CONDITIONS OF APPROVAL:

Engineering - Final Plat Checklist

514716014_2017-03-02_Final Plat.pdf

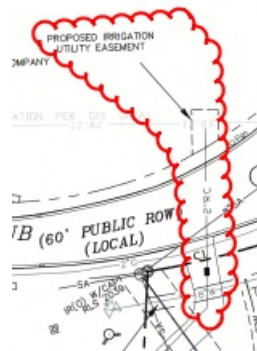
joe.marlo@franklinton.gov The comment "The comment has been partially addressed (thank you), however some of the utilities shown do not match the Site Plan, and the utilities shown on the Site Plan have been revised from the previously reviewed submittal.

- The utilities shown on the plat shall match the site plan. Note that the 20" water line(s) in particular are incorrectly shown.
- Storm infrastructure shown on the plat outside of easements shall be labeled as private.
- Sewer infrastructure shown on the plat outside of easements shall be labeled as private."

has not been addressed by the applicant. Applicant shall address comment.

The applicant shall revise the plat as follows:

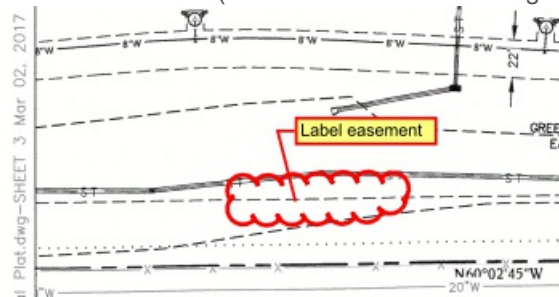
joe.marlo@franklin.tn.gov The comment "Applicant shall ensure that any modifications to the site plan, which is being reviewed concurrently with this final plat, are reflected on the final plat. The final plat shall match the site plan." shall remain open until the Final Plat matches the Site Plan.

Applicant shall make special note to revise the following areas to match the Site Plan.

1. Label easement (TVA Easement Bk. 3502 Pg. 594 per Site Plan)

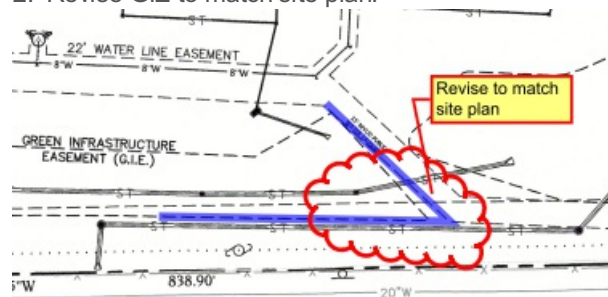
2. Revise GIE to match site plan.

3. Revise water utility easement to match site plan.
